Reference: Innovus
Application Number: DA-2241-05
Case Number: 2023-6006-00; 2023-3005-00

Thank you for your review of the Innovus Site Plan Submittal dated 5-23-2023. Please see below for a response to your review comments:

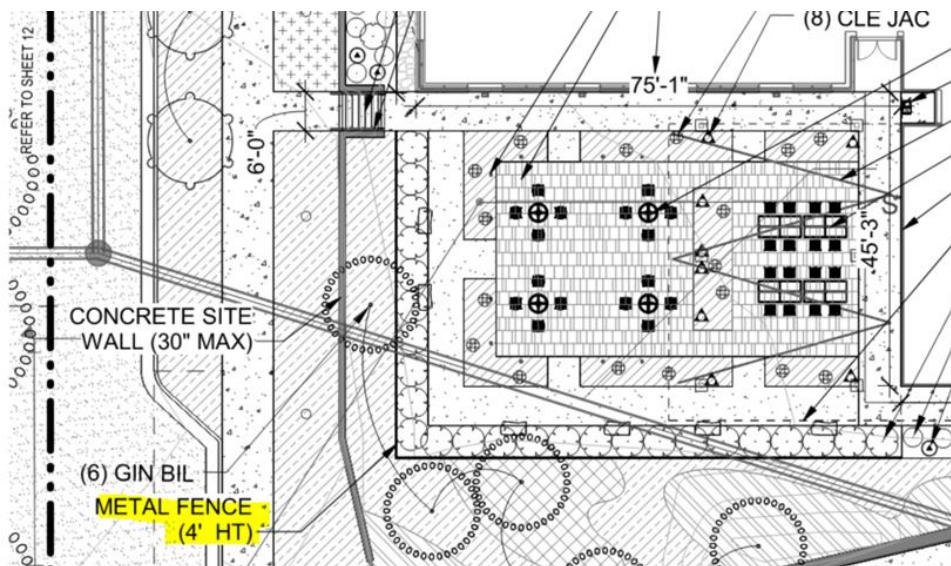
4J. The landscape table indicates that two trees have been provided, but there are no trees within 20' of the building's face. Add a note to the building perimeter landscape table that given the proximity of the patio to the building, the trees have been located along the perimeter of the patio area.

4J RESPONSE: A note has been added to the Building Perimeter Landscape Table on Sheet 10: "GIVEN THE PROXIMITY OF THE PATIO TO THE BUILDING IN THIS LOCATION, THE TREES HAVE BEEN LOCATED ALONG THE PERIMETER OF THE PATIO AREA."
